SERVICE BULLETIN

BULLETIN #: 16-08-41 Rev A

MODELS CONCERNED: A25-50HE / V25-50HE / A230D / V230D

INFORMATION: A series reverse pedal contacting running board rim

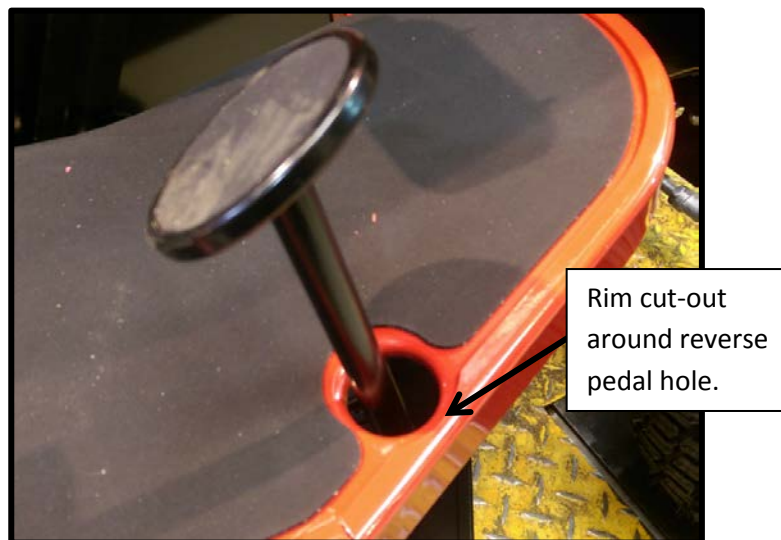
A potential issue has been identified that in some circumstances it may be possible for the reverse pedal on the A series tractors to contact the running board rim.

This can slow down the return of the pedals to the neutral position and in extreme cases it has the potential to stop the pedals returning altogether. Please note that it does not lock up the pedals, a simple touch with the foot will allow it to return easily to neutral.

To help prevent this situation occurring a cut-out has been added to the rim as shown in the picture below.

On tractors that don't have this cut-out (prior to serial # A0330761) it is advisable to check if the reverse pedal touches the rim by pressing the forward pedal to its limit. This will cause the reverse pedal to rise up through the running board and if contact is observed then the running board should be changed for one with a cut-out. The part number for the RH running board is:

321122500
